SECOND REVISION
PLAN COMMISSION
MEETING NOTICE AND AGENDA
Thursday, September 21, 2023
6:00 PM

Project Name: WVRC Conditional Use, Rezoning, and Site & Building Plans

IMPROVEMENT PLANS FOR
WVRC EMERGENCY VET
CITY OF PEWAUKEE, WI

C101

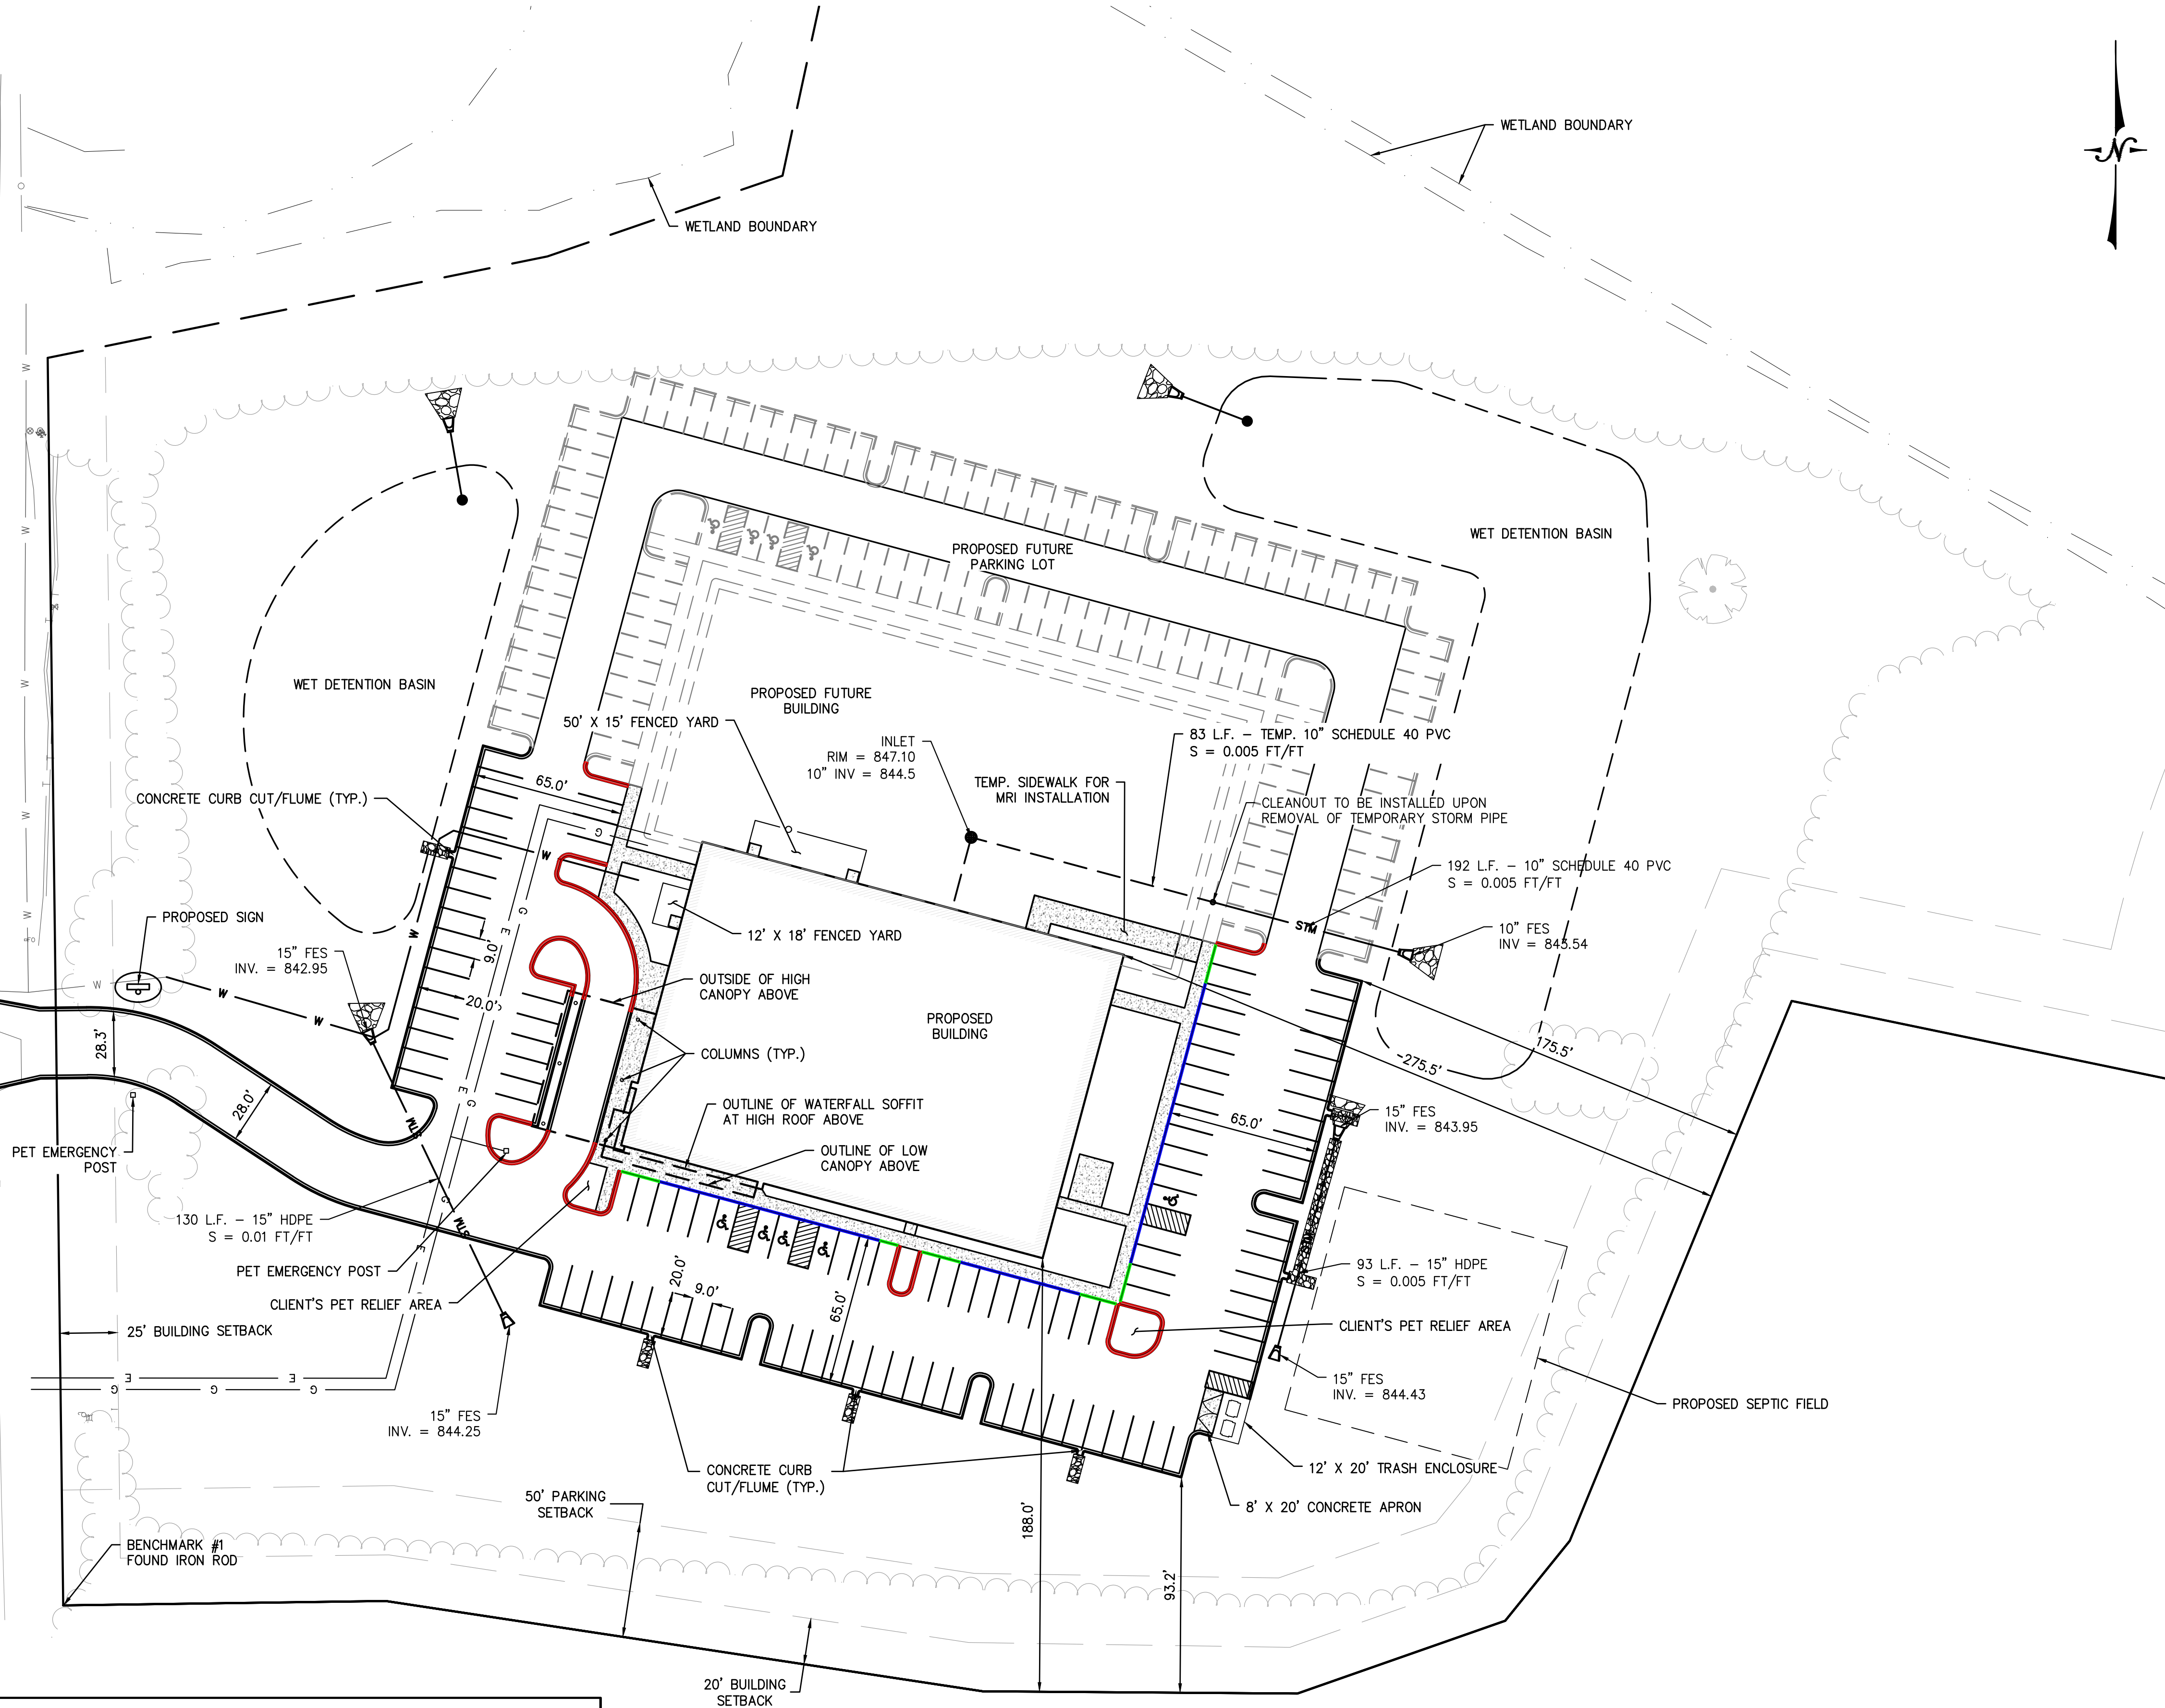
3. A concrete curb cut will be required along the east curb line near the proposed septic field (See Sheet C102 comments). **Low point and corresponding curb cut has been added to the plans.**

4. Identify that improvements within the CTH J right-of-way will be included in this project. **A note has been added to see sheet C404 for all CTH J improvements.**

CONSTRUCTION DETAILS	
NO.	BY DATE
1	TCL 06-09-23
2	TCL 08-04-23
REVISIONS	
UPDATED SITE PLAN	
CITY REVIEW COMMENTS #1

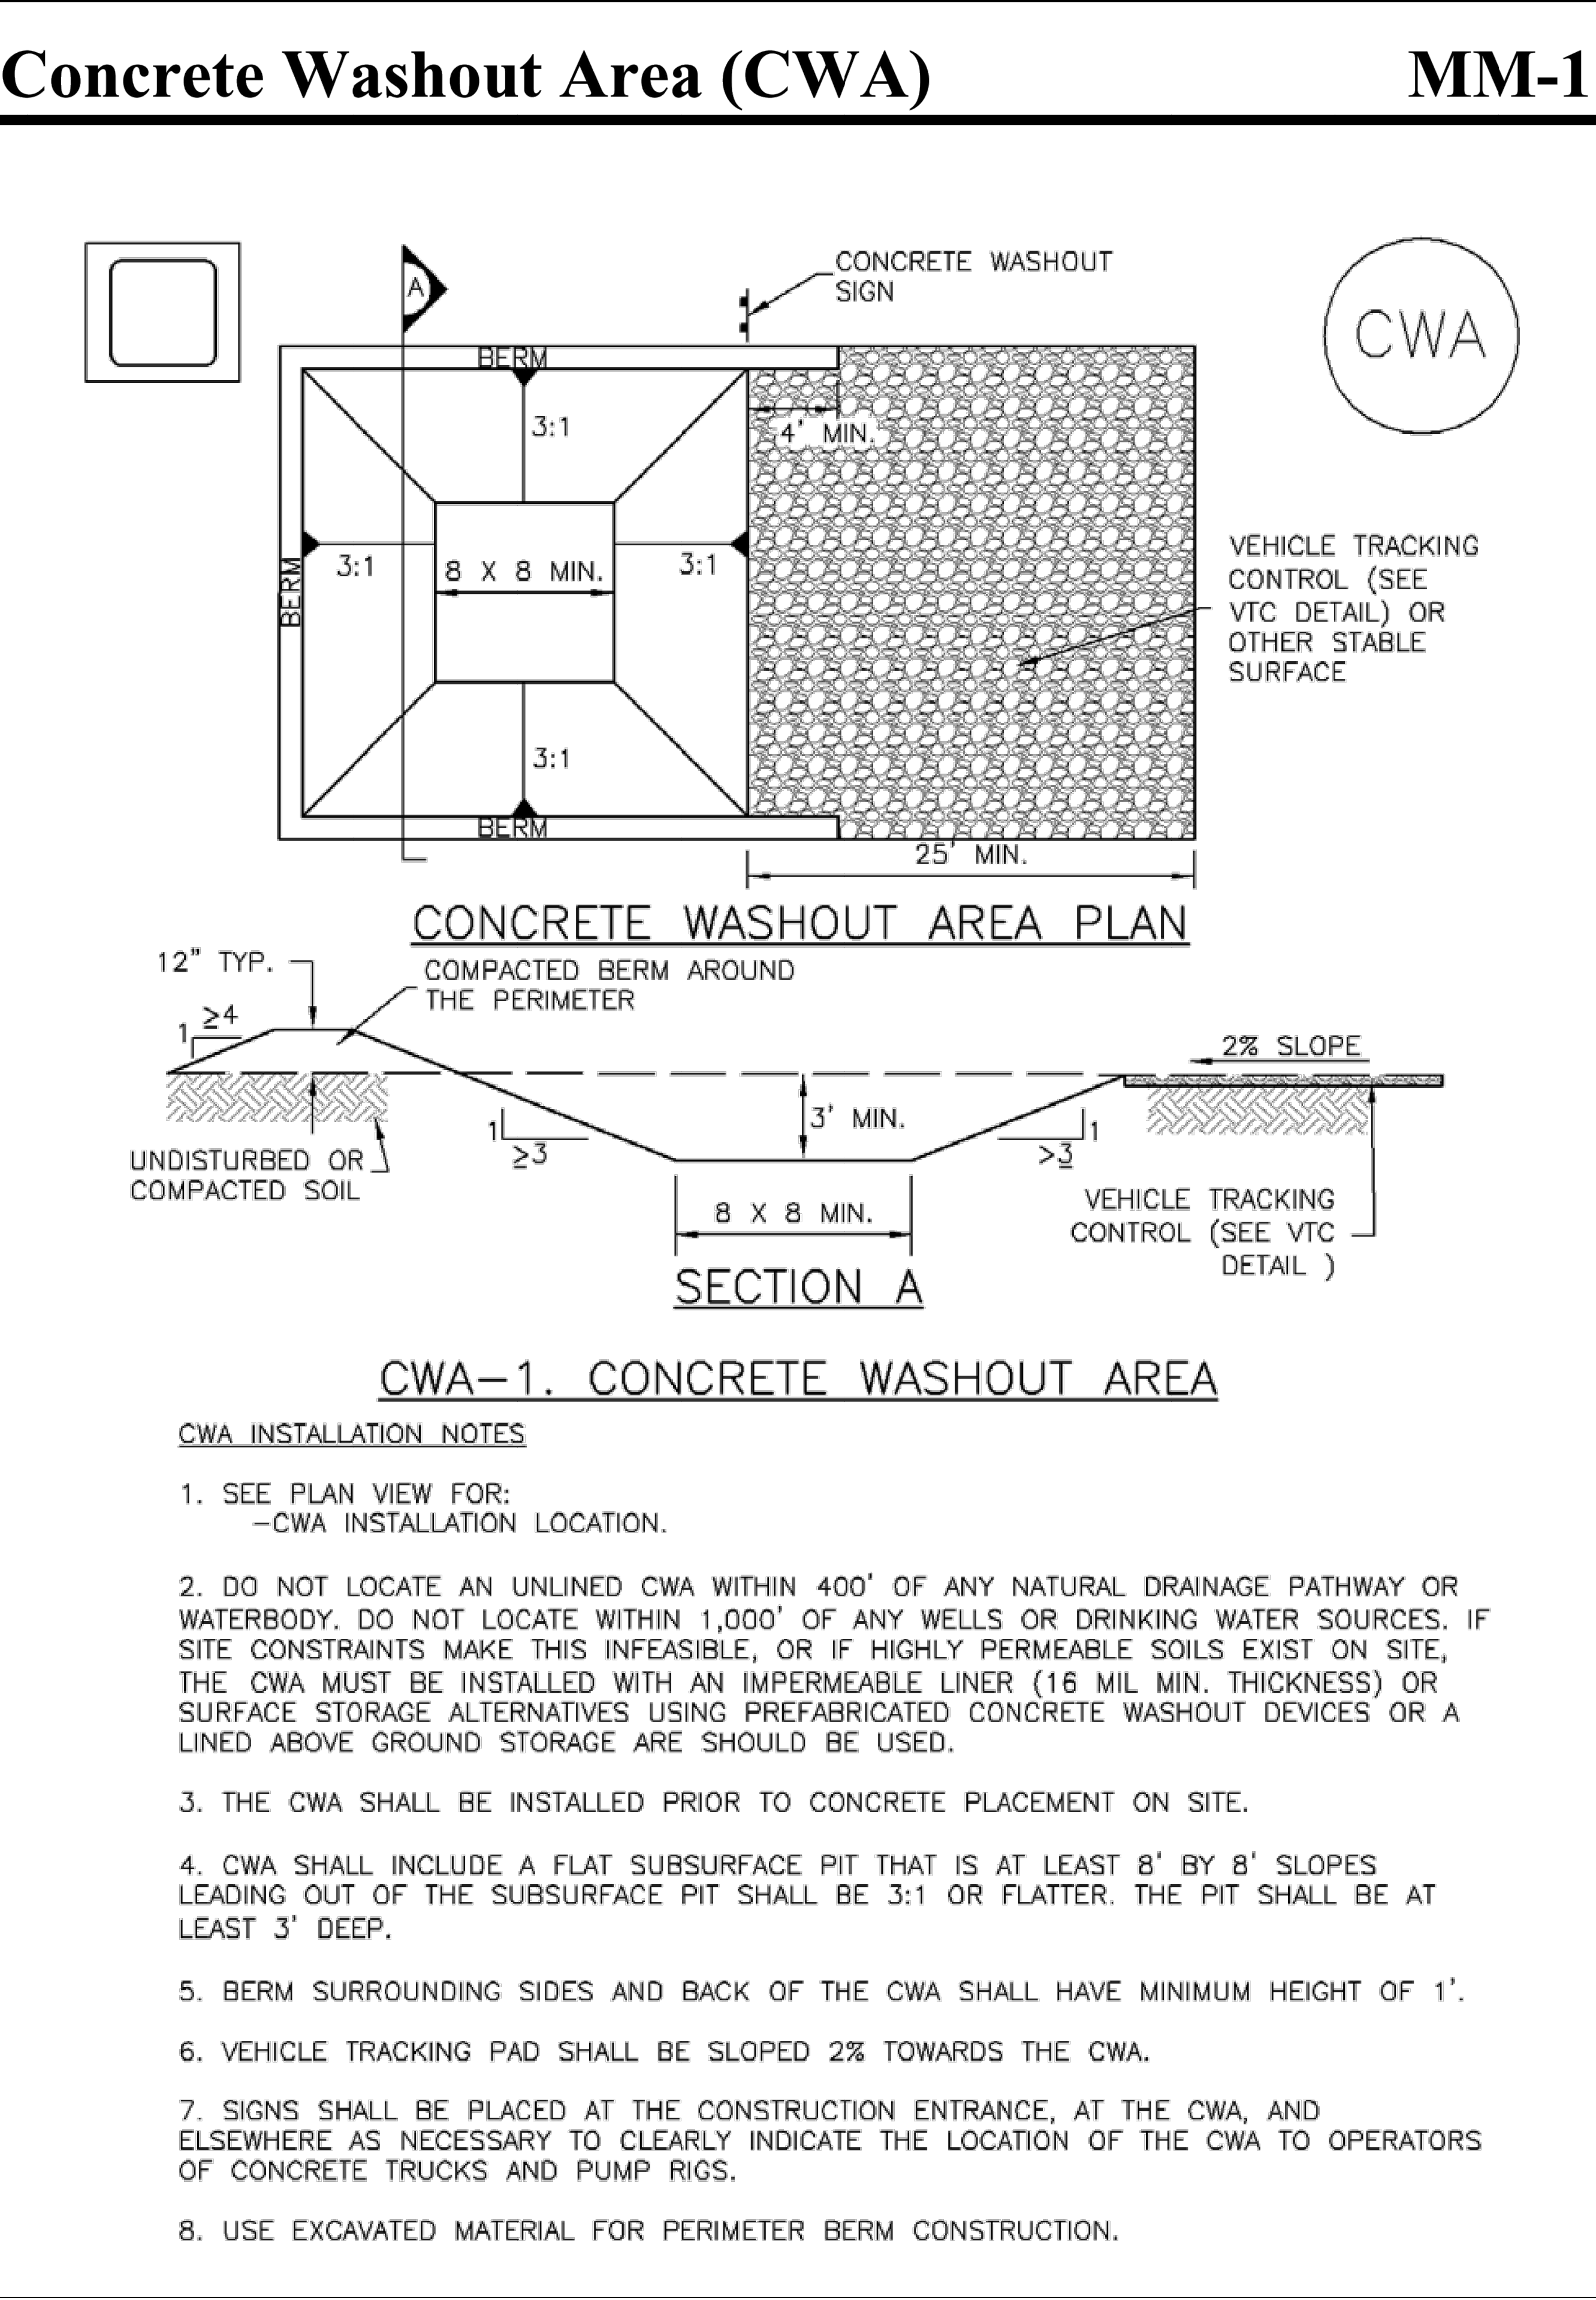
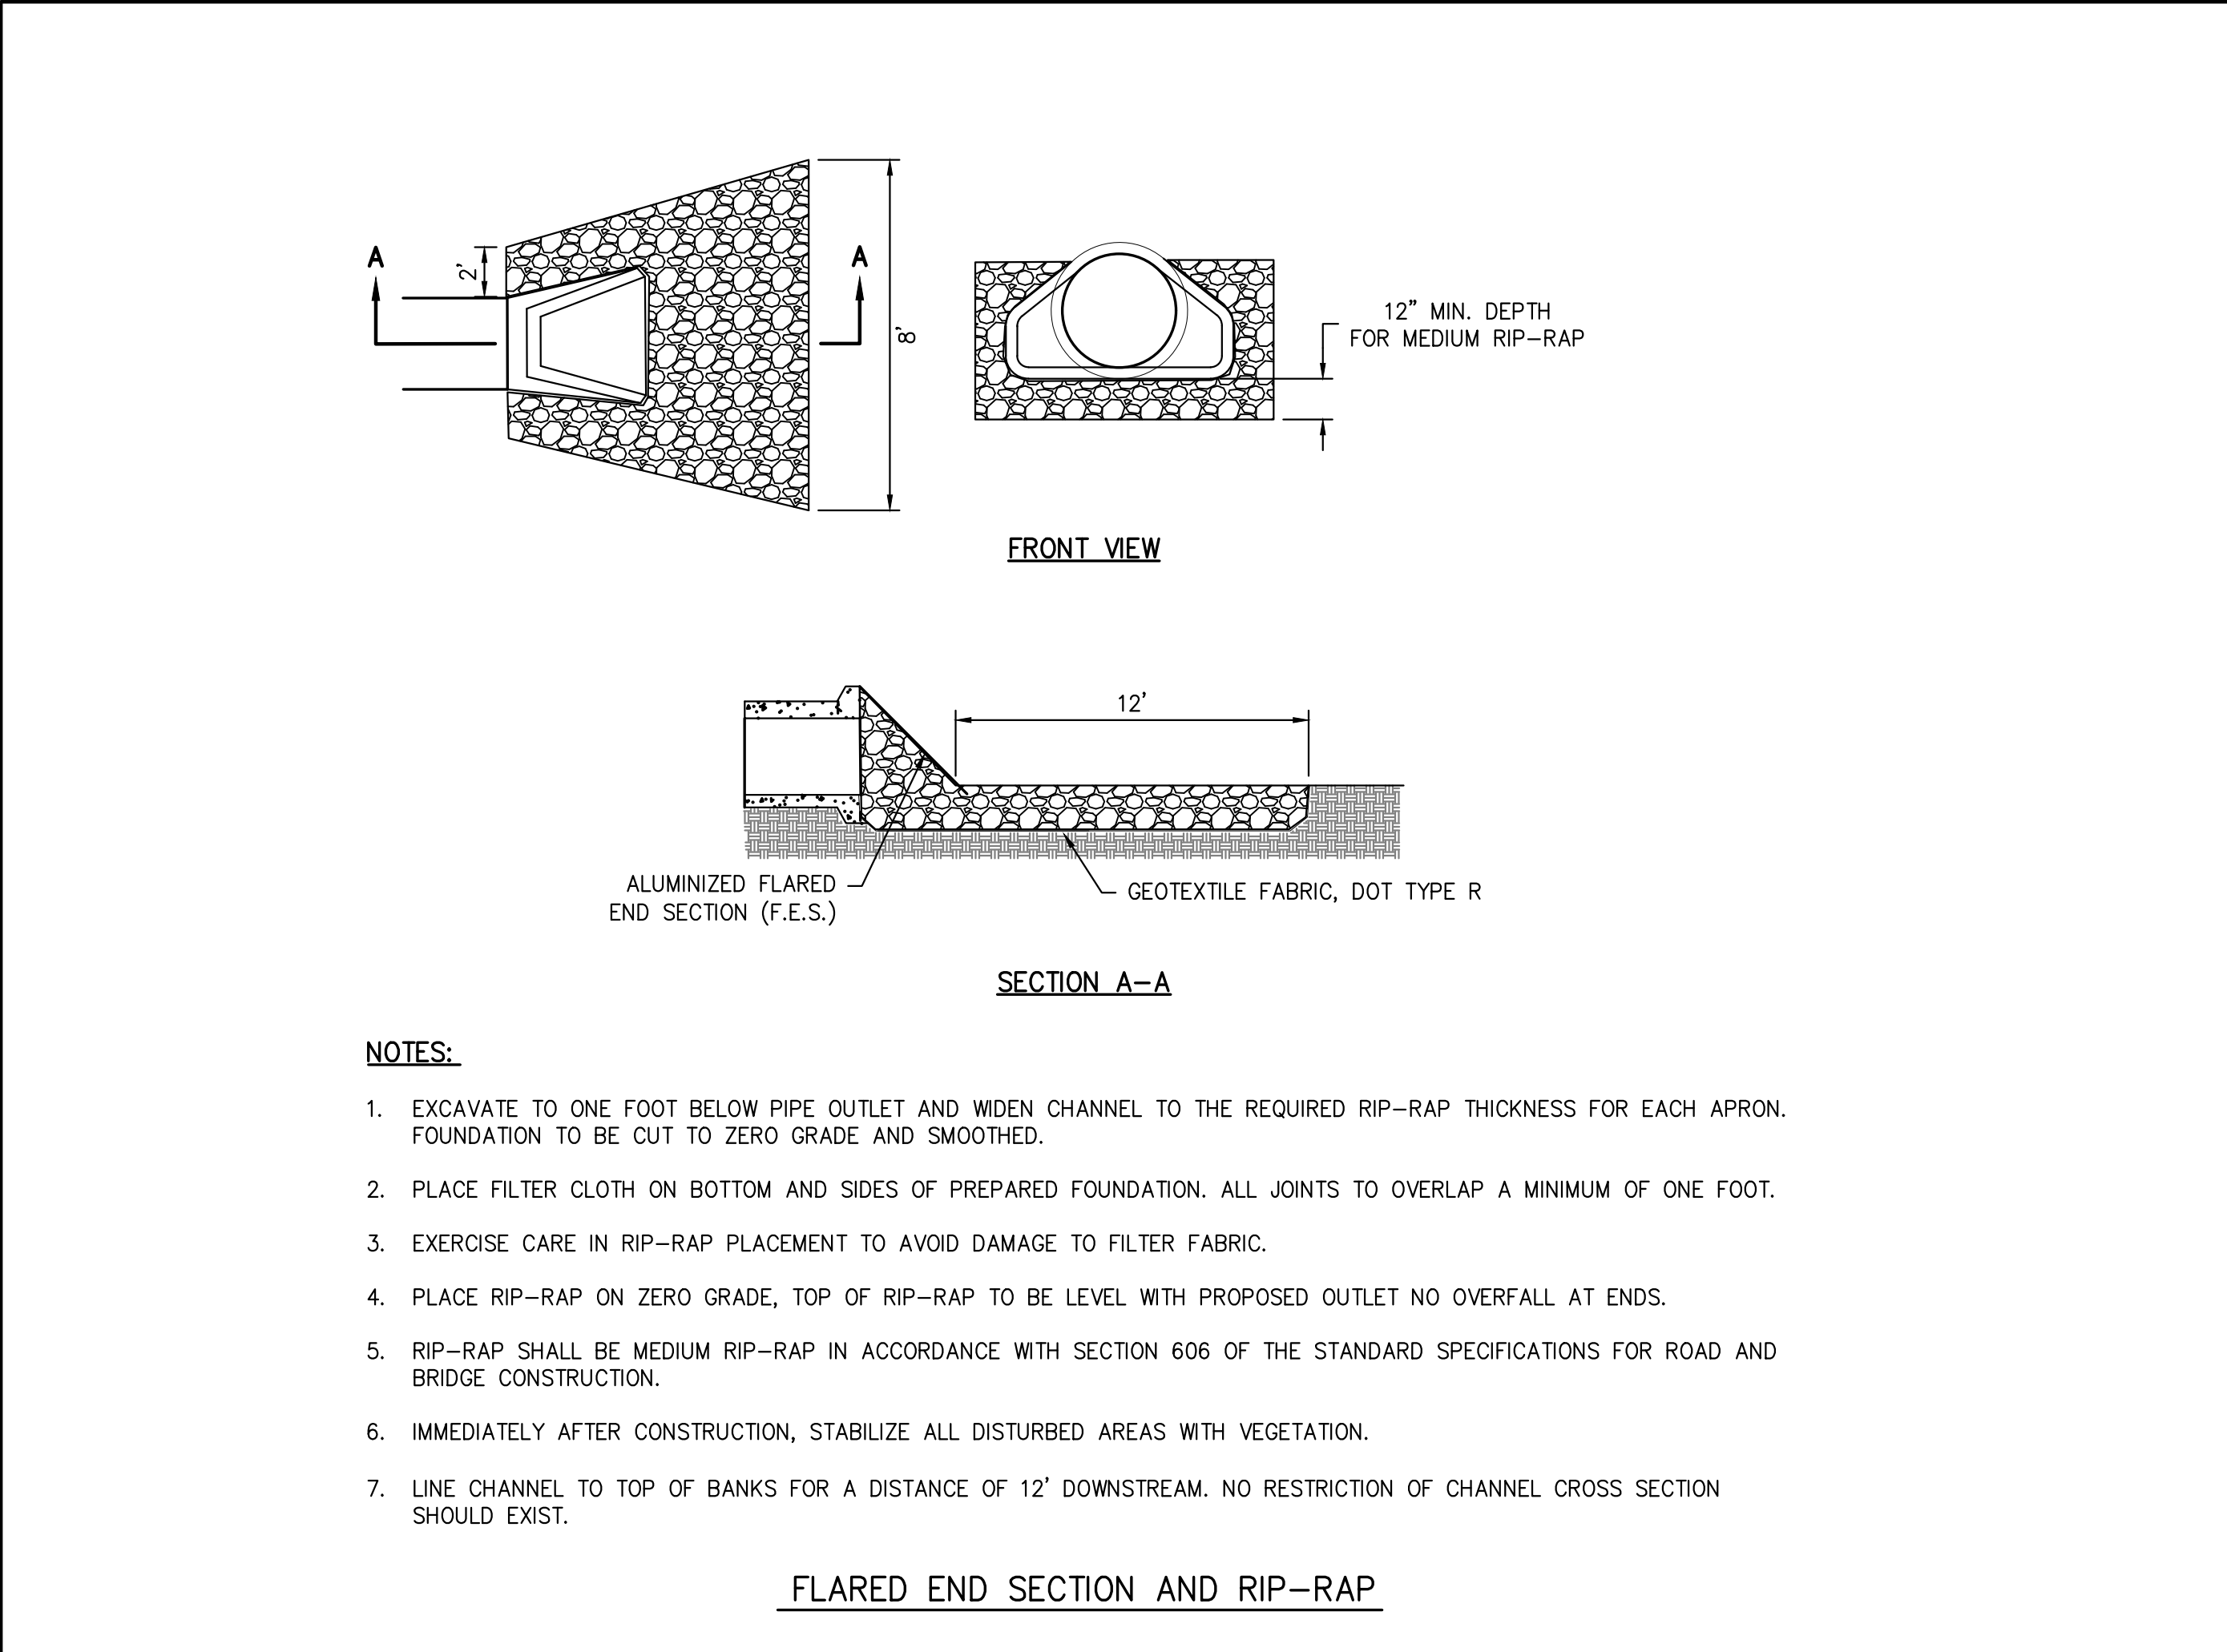
1. Show the location and details for the proposed concrete washout on site. **Concrete washout has been added to sheet C103, and a detail has been added to sheet C503.**
2. Revise inlet protection detail to show type A and type D inlet protection. All inlet protection placed on site should be type A or type D. **Inlet protections details for type A and D have been added to sheet C501.**
3. Include a detail for the proposed orifice trash grate. **Detail has been added to sheet C503.**
4. Revise the end section and riprap detail to show placement of medium riprap following the flared end section. **Detail has been updated from light riprap to medium riprap.**
